**APPLICATION FOR PERMISSION
UNDER SECTION 16 OF
THE TOWN PLANNING ORDINANCE
(CAP. 131)**

For Official Use Only 請勿填寫此欄	Application No. 申請編號	A/YL-LFs/577
	Date Received 收到日期	15 OCT 2025

(a) Proposed use(s)/development 擬議用途/發展	Proposed Temporary Open Storage of Construction Machinery & Construction Materials for a Period of 3 Years (Please illustrate the details of the proposal on a layout plan) (請用平面圖說明擬議詳情)

Below is the response to the comments from GEO in their email dated 22 Jan 2026.

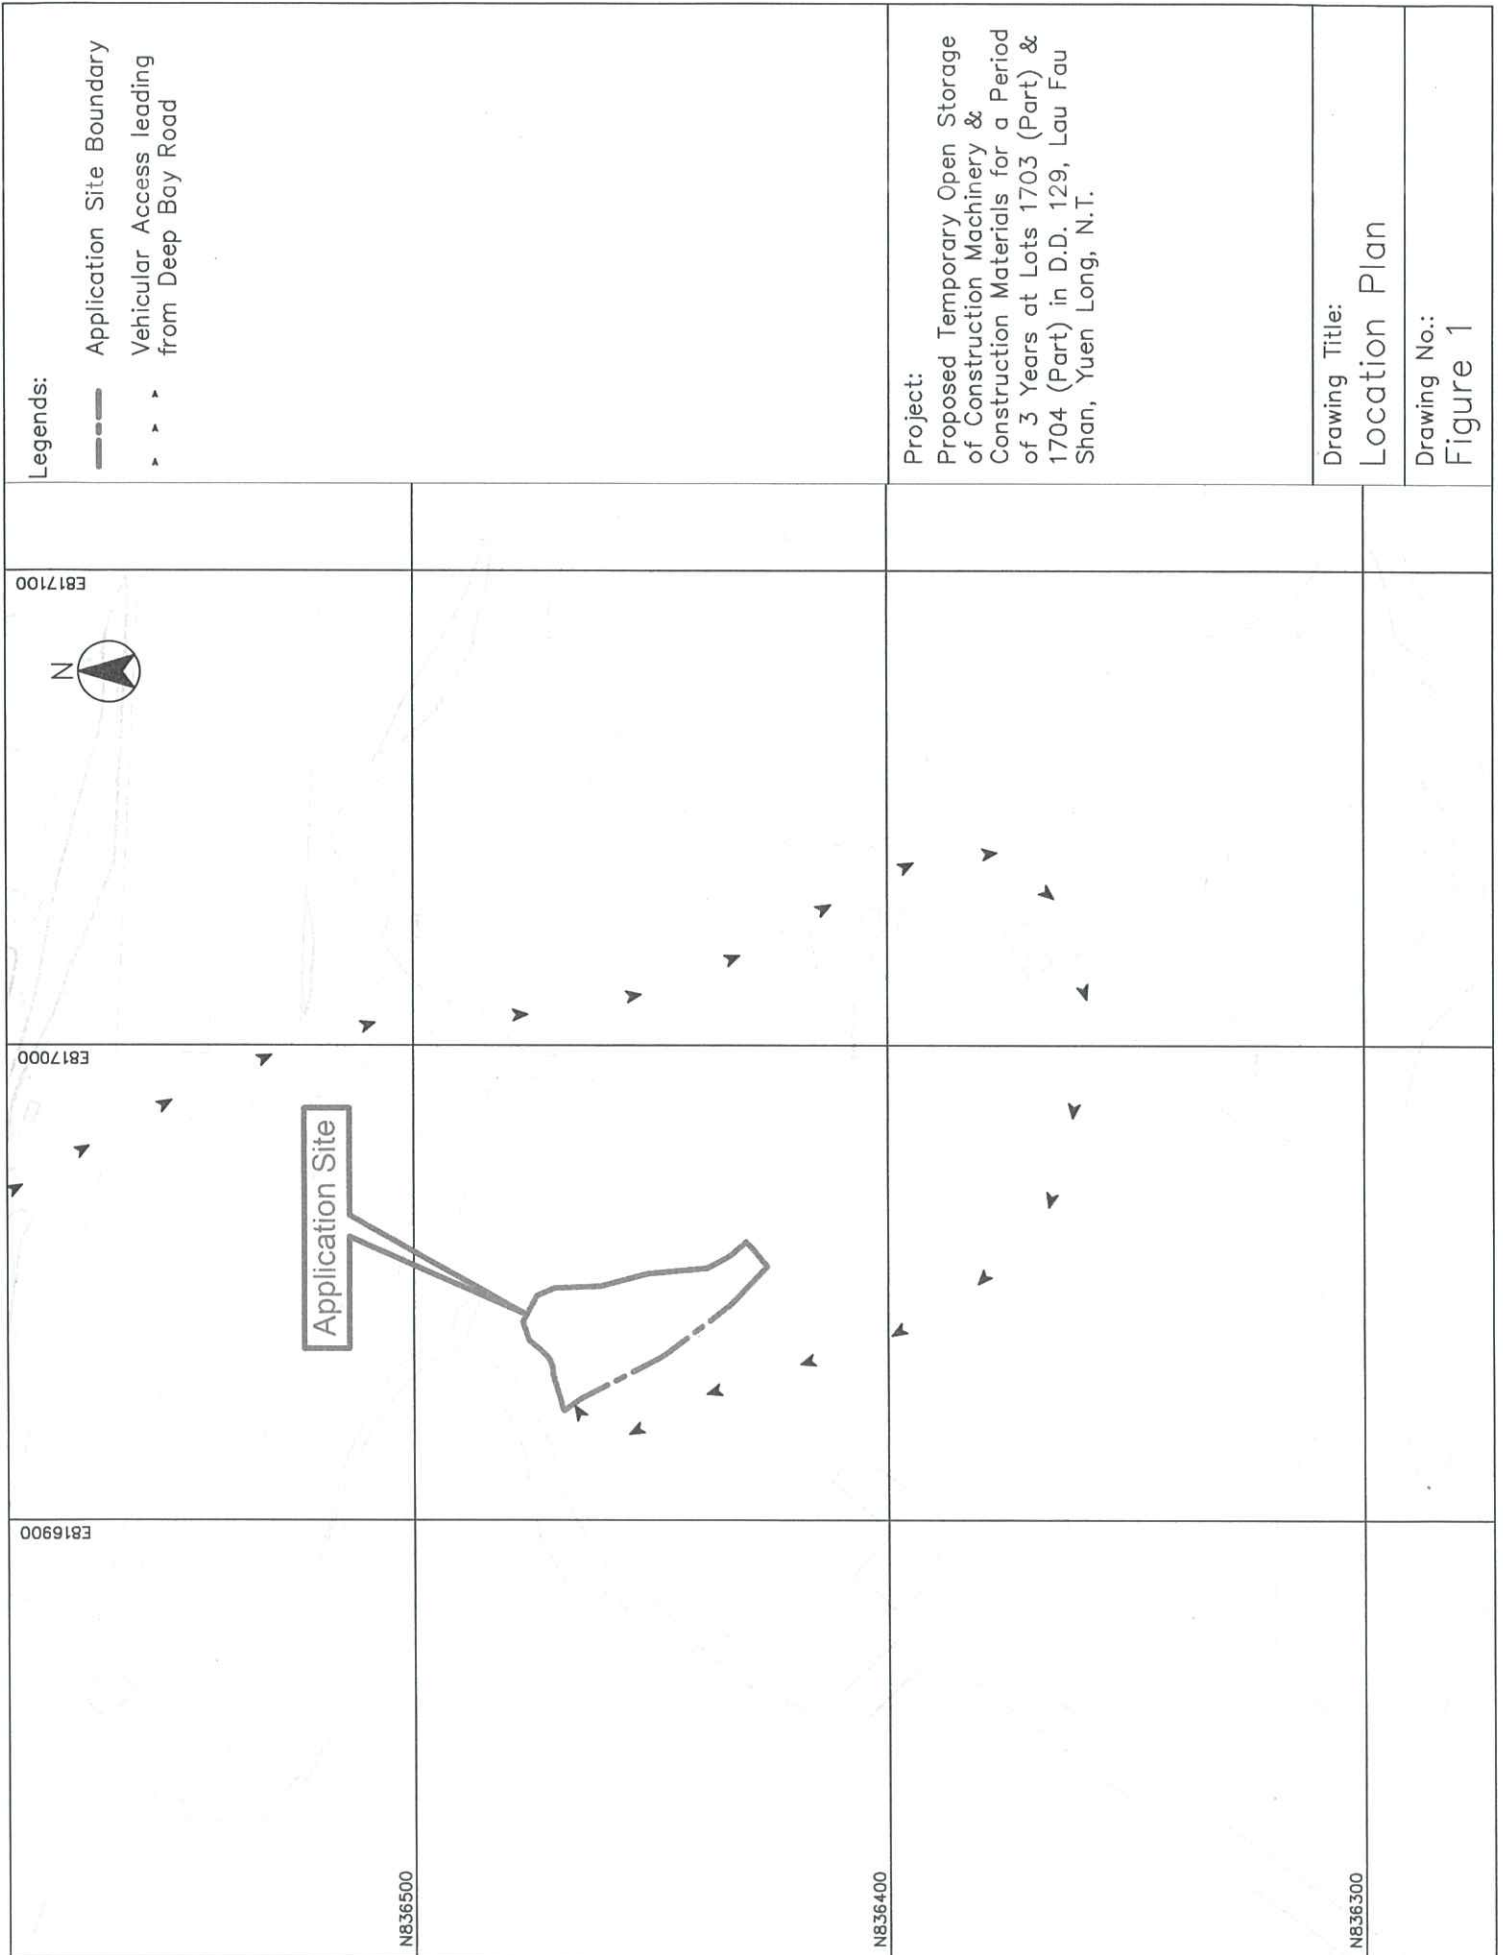
Description	Response
<p>1. Referring to Section 2 of the GPRR, a 15m long sheet pile wall on plan was found at the crest of Feature No. 2SW-C/C112 adjacent to the application site. The applicant should provide an accurate survey plan to show the existing nature of the site and the surrounds (including the existing slope, sheet pile wall, water mains, drains and other services). The approximate extent of the survey plan is shown on the attached Plan A.</p>	<p>The survey was carried out accordingly, the results are shown in Figure 3 of the Report.</p>
<p>2. It is noted from Section B-B in Figure 5 of the GPRR that the sheet pile wall is supporting a newly formed platform located within the application site (see attached Plan B). The type of filling materials and extent of the newly formed platform should be investigated. The stability of the slope, sheet pile wall and the newly formed platform should be assessed and proposed rectification works should be provided, if found necessary.</p>	<p>As shown in Figure 3, only a short length of the sheetpile (i.e. 0.866m compared to the overall length of 16.8m) has entered into the Application Site. The boundary of the Application Site has then shifted back for a distance of 6.8m from the sheetpiles, which is beyond any newly platform formed and the crest zone recommended in GEO Technical Guidance Note No. 15 (TGN 15). In addition, drainage has been provided to avoid causing surface erosion to the slope.</p>
